Department of Energy
Carlsbad Field Office
P. O. Box 3090
Carlsbad, New Mexico 88221
November 1, 2004

Subject: Initial Response to Environmental Protection Agency (EPA) September 2, 2004, Letter on Compliance Recertification Application

Figure 1. Piper diagrams for samples collected from WQSP wells from 1995 through 2002.

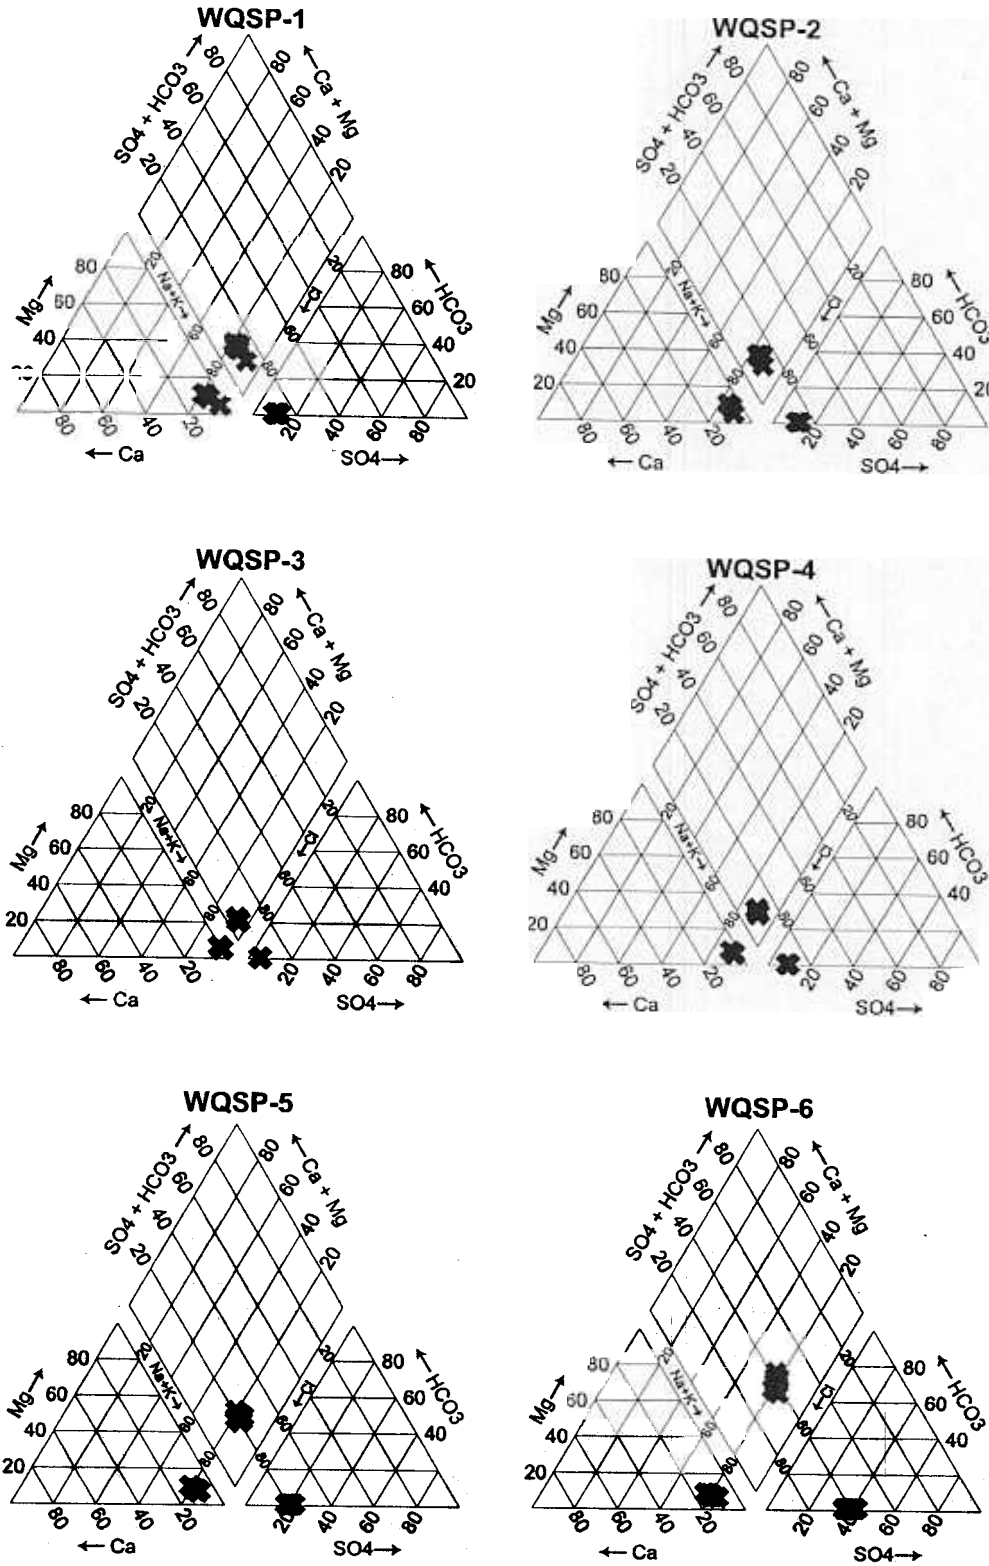
DOE has removed discussion of all "background" environmental conditions, but does not address how information obtained since the approval of the CCA may have affected these "background" conditions. For example, groundwater monitoring has occurred for several years, yet the discussion pertaining to Water Quality remains unchanged with respect to the hydrochemical facies.

The discussion pertaining to water quality has not changed since the CCA because monitoring has detected no changes in groundwater quality. Figure 1 shows Piper diagrams with the results of 15 rounds of sampling at the WQSP Culebra wells conducted between 1995 and 2002 (WRES 2003). The first 10 rounds (collected through May 2000) were used to establish baseline concentrations of the major ions (IT Corporation 2000). No changes to the baseline hydrochemical facies were observed over the five subsequent rounds of sampling. WRES (2003) presents time-trend plots for the major ions and other water-quality parameters for all 15 rounds of sampling, showing the absence of changes from the baseline values.

Figure 2-57. Seismic events with a magnitude greater than 3.0 within 150 miles of the WIPP site.

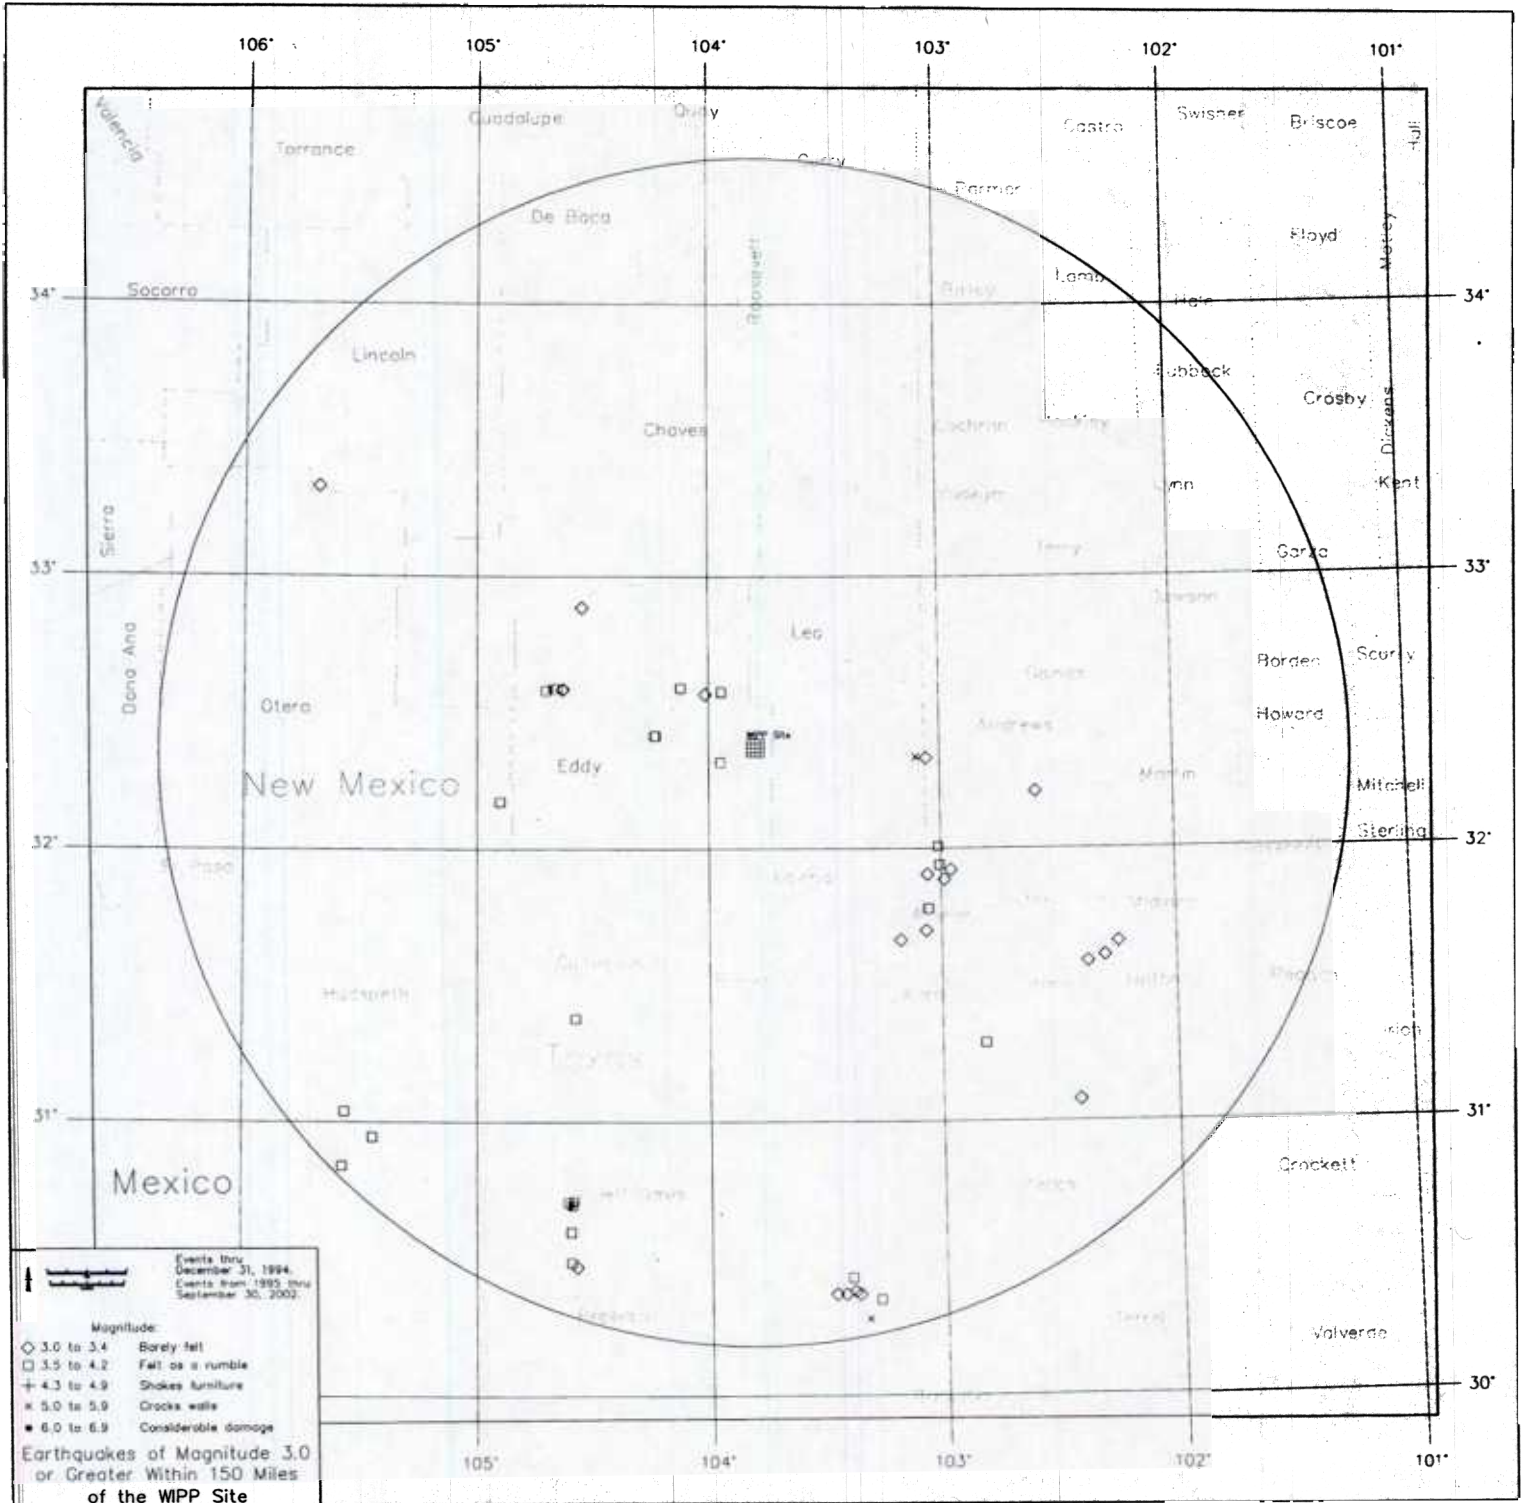
The CRA includes a discussion of seismicity in the WIPP vicinity, but does not discuss post-CCA seismic events. If no events occurred, the CRA should so state. Additionally, Figure 2-57 does not clearly present events that are “post CCA”, even though the title of the figure implies that it includes these events. DOE needs to identify the seismic events that have occurred since the CCA.

Figure 2-57 has been updated to show the seismic events with a magnitude greater than 3.0 within 150 miles of the WIPP Site. The seismic events in black occurred during the CCA time frame, while the events in red are from the CRA time frame. Also provided is a table that defines the location, the magnitude, the time, and the date of each event in Figure 2-57.
